GENERAL APPLICATION

Location Address: 106 S State Road 7, Hollywood & 190 S State Road 7, Hollywood

Explanation of Request: Demolition of existing buildings and re-development of the site into a 6,133 SF convenience store and gas station (20 fueling positions)

CANOPY PERSPECTIVE VIEW

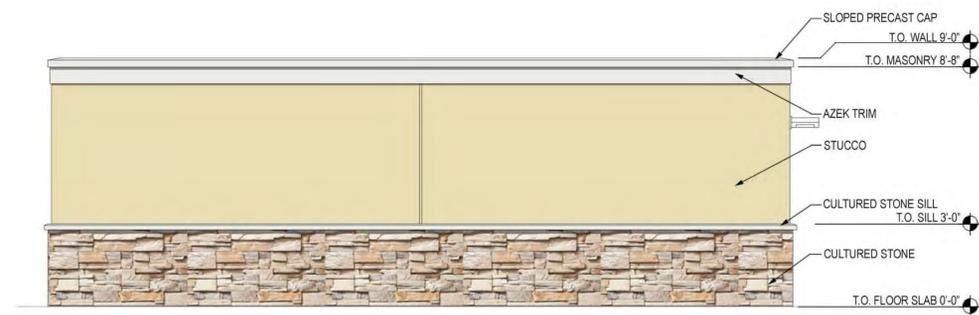
2. The roof section depicted Side Elevation of canopy does not appear to match the one shown on Perspective View. Please clarify.

Response: The side elevation of the canopy has been revised to match the perspective view.

View looking northwest from U.S. Hwy 441

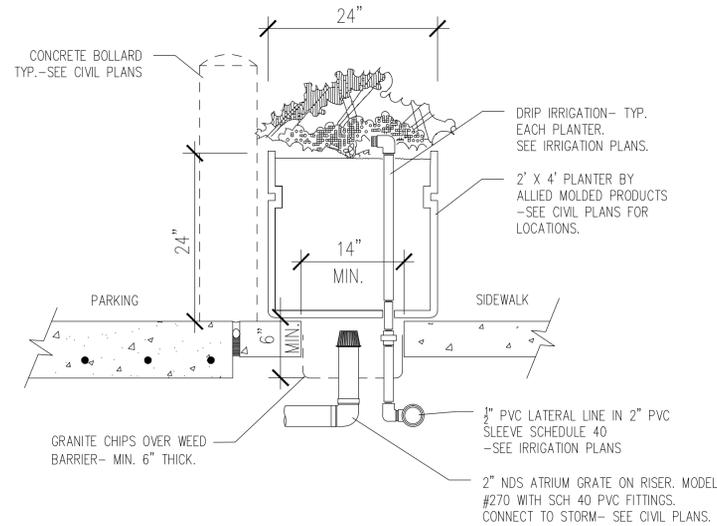
3. Aerial Photomatch page shows the driveway at southwest corner of proposed development as an exit. Plans indicate this driveway is on entrance. Please clarify. This view also reflects improvements to parking lot islands south of the proposed development. But these improvements are not shown in the plans. Please Clarify

Response: Aerial Photomatch has been revised to match current plan set.
